**Addendum No. 2
December 13, 2021**

Project: Corsica-Stickney Elementary School Addition
Stickney, South Dakota
Architect's Project No.: 2910
Architect: Architecture Incorporated

ADDENDUM M2

ADDENDUM #E2

4.11

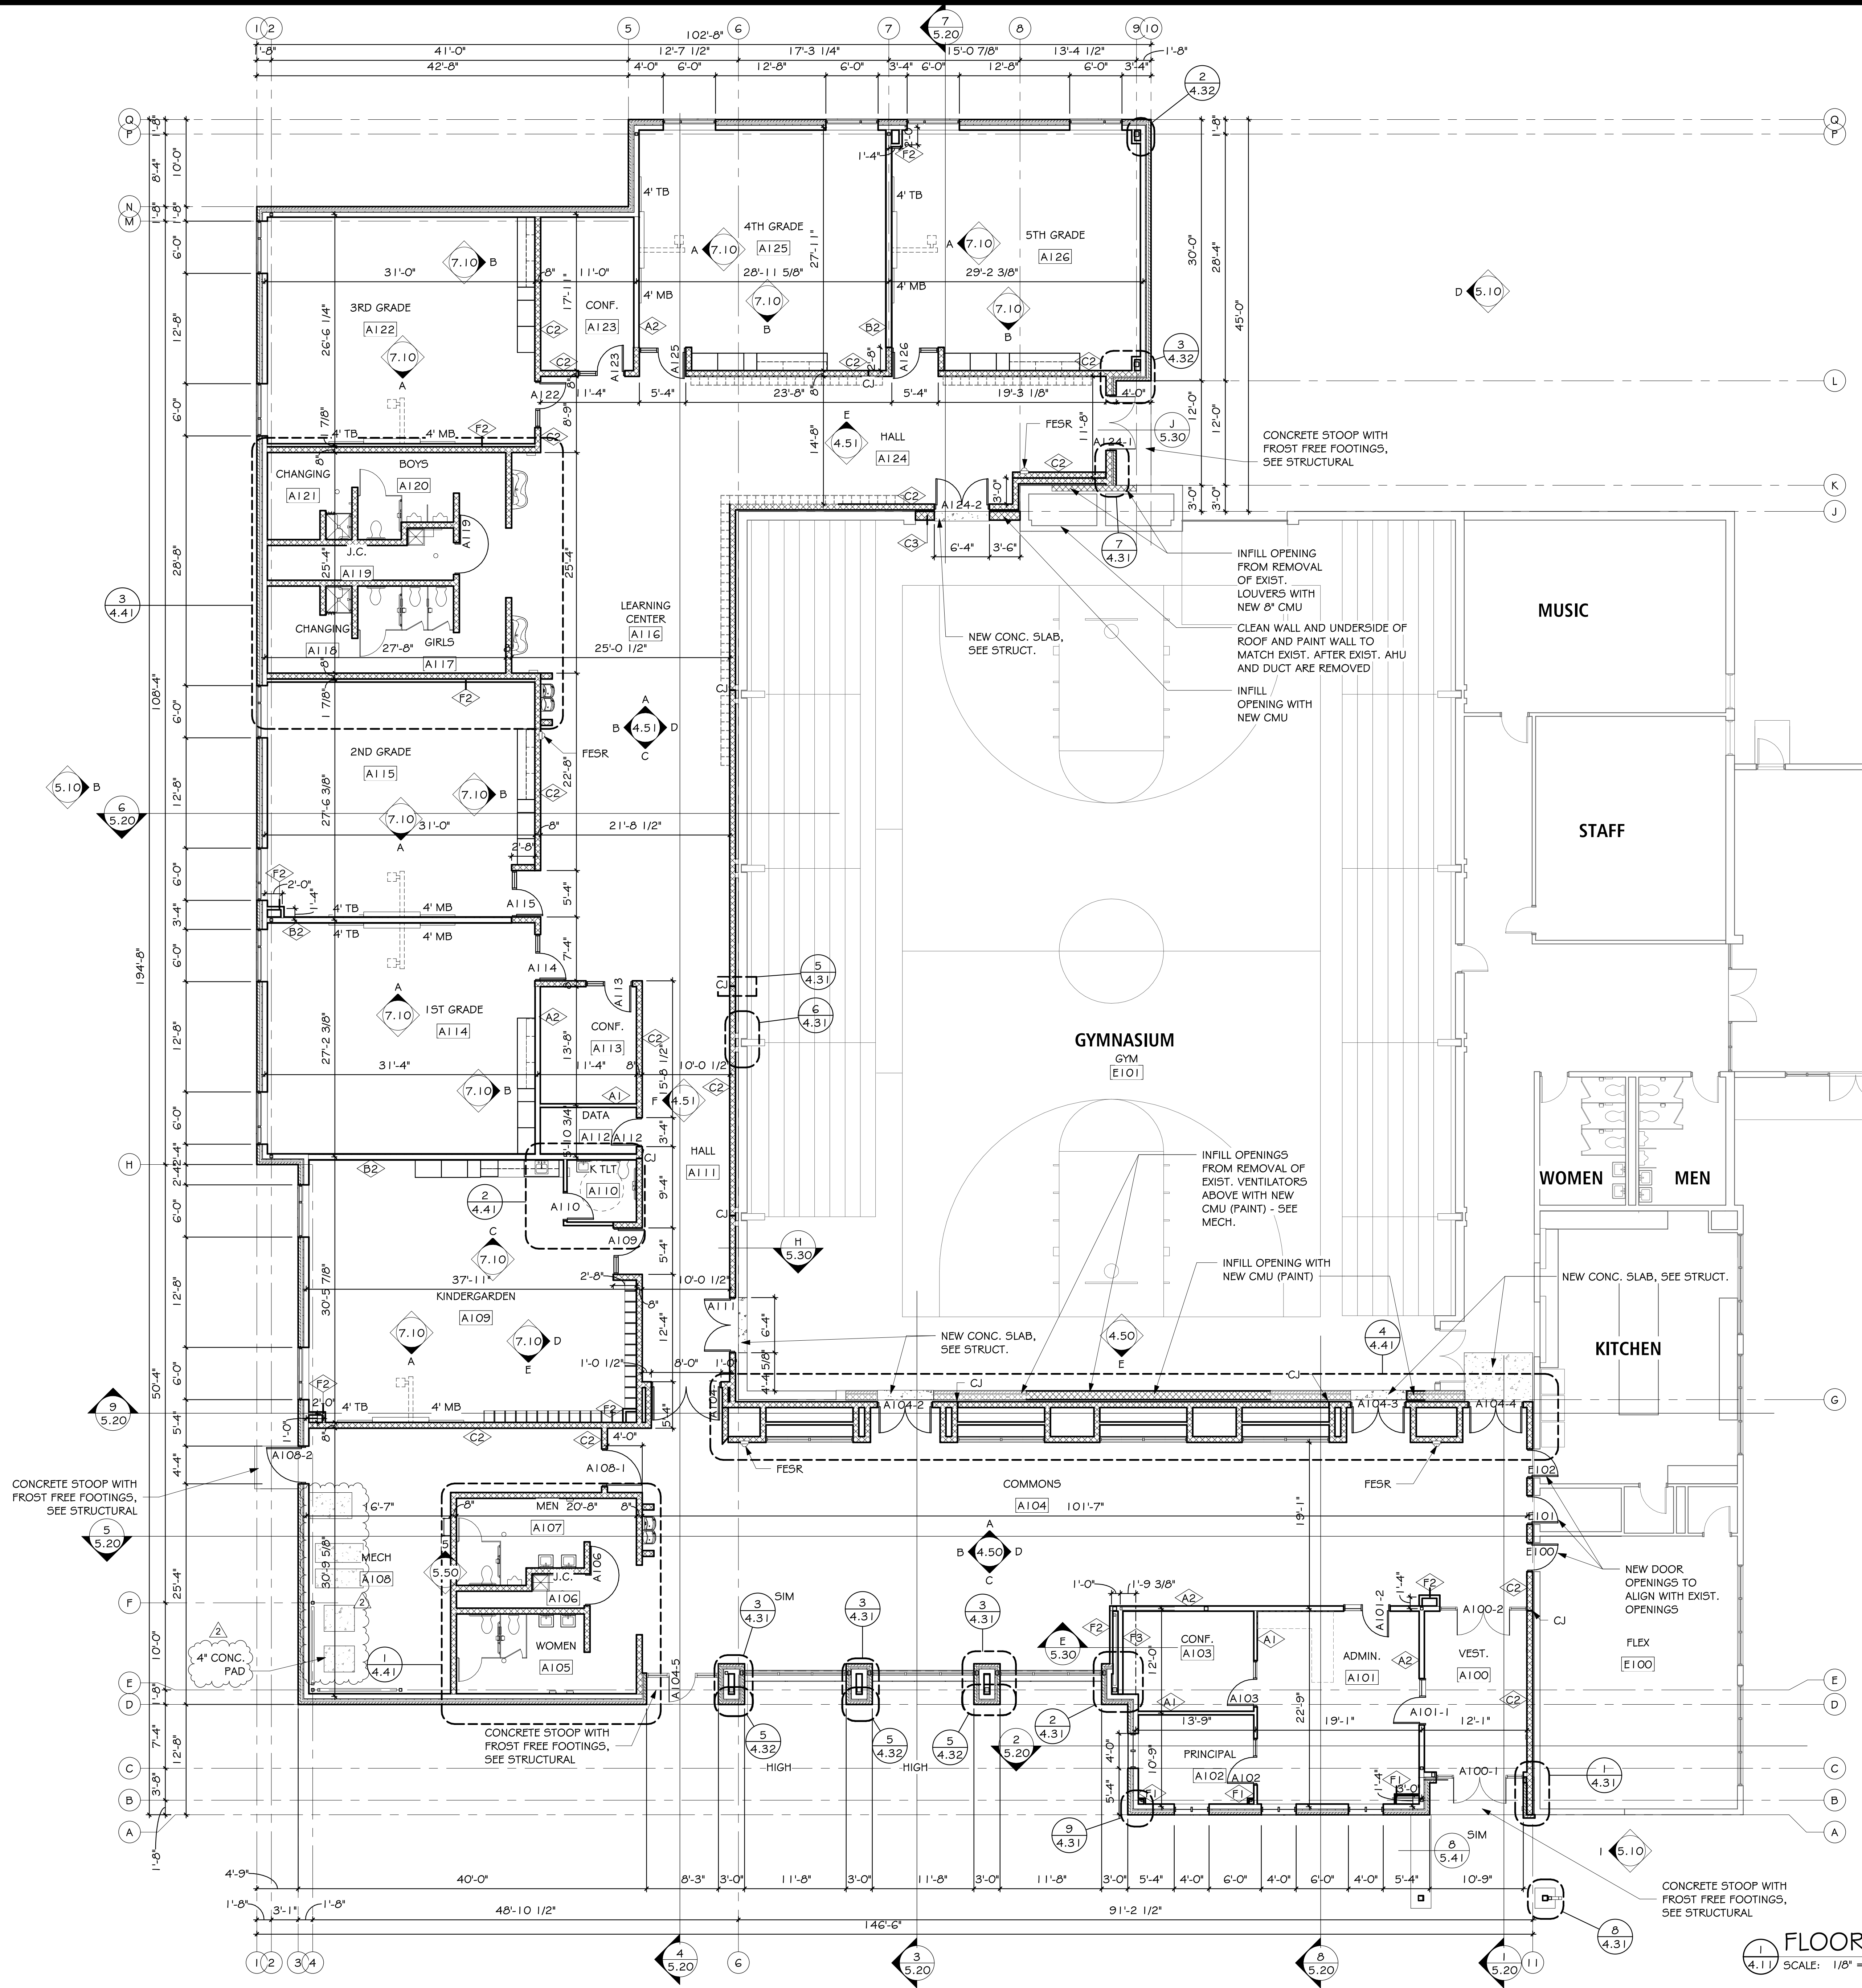
- 1) SHEET 4.11 FIRST FLOOR PLAN: See new sheet with changes clouded and tagged with "2"
 - a) **ADD** Notes and concrete pattern hatch in mechanical room for 4" concrete housekeeping pads

DRAWING SHEET 9.31 – FIRST FLOOR PLAN – POWER & SIGNAL

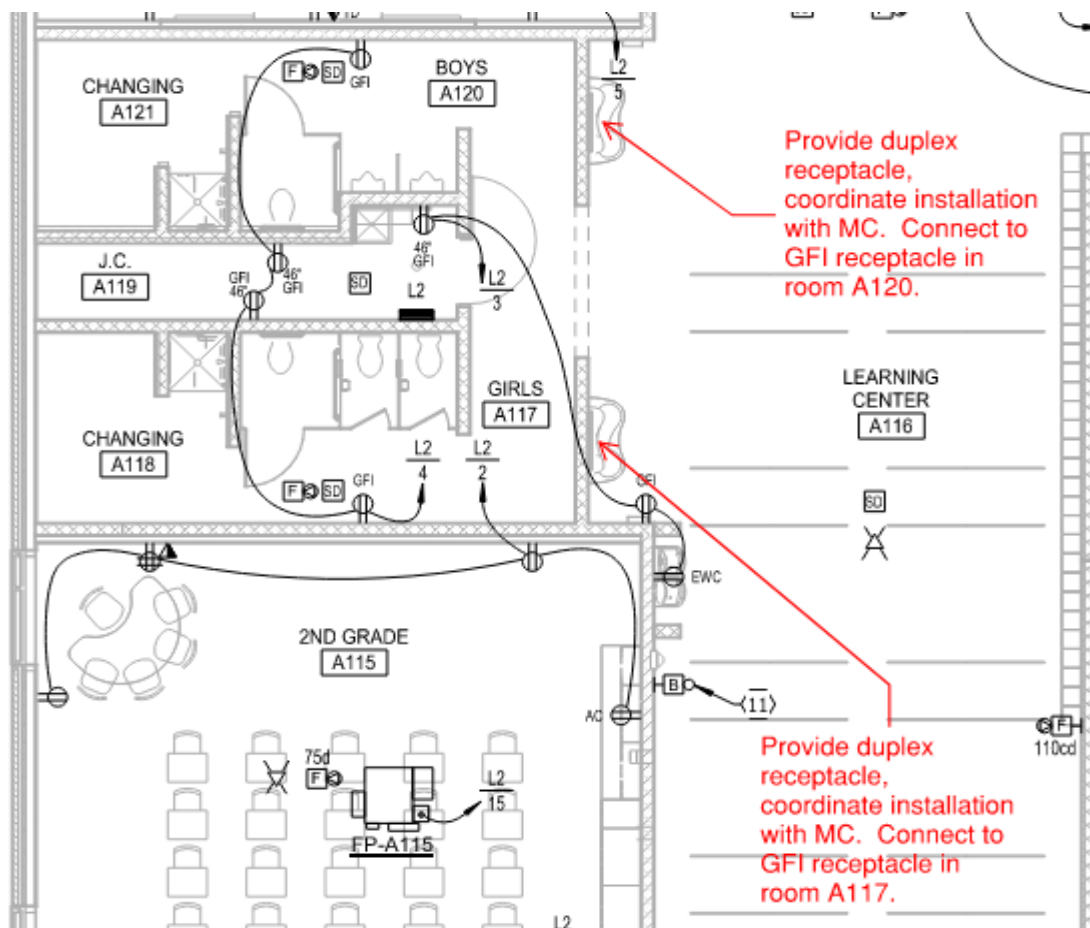
1. Room A116: Provide duplex receptacles as shown below.
